RAPID UPDATE

Rapid Update 825 Maserati GranTurismo – Oil Sensor Wiring Check

VEHICLES INVOLVED: (M189) GranTurismo, (M190) GranCabrio MY24 – MY26

Inspection Procedure

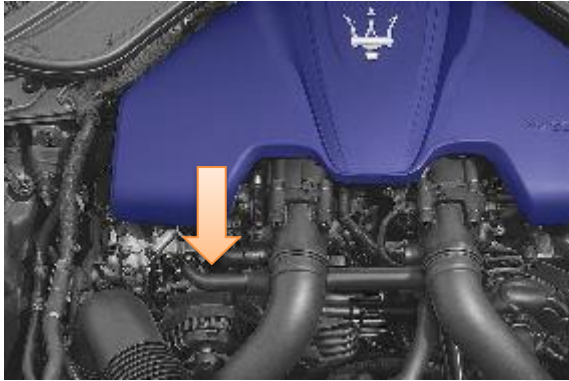
1. Always check ModisCS+ to see if the vehicle is involved in this action and if it has not been previously performed.
2. Before performing any operation, disconnect the battery following the workshop manual procedure:
 - a. **8.20.001 - BATTERY - Power supply Connecting/disconnecting**
3. Open the front hood and locate the alternator. **Note:** An endoscope is required for this inspection.
4. Insert the endoscope probe behind the alternator to identify the wiring harness and its retaining clip.

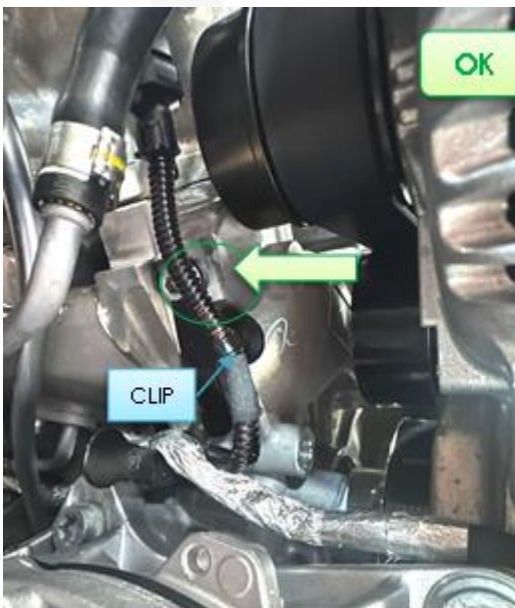
5. Check that the wiring harness is positioned **as far as possible from the alternator pulley** and no excessive slack or deformation is present that could allow contact.

Note: As a reference, locate the bracket screw. The cable must be **routed above the screw, without bends.**

6. If the cable **does not present any abnormalities**, the car is **OK** and can be deliberated.
7. Otherwise, if incorrect routing or damage is found (abrasion, breakage, exposed wires), the vehicle is **non-compliant** and must be repaired.
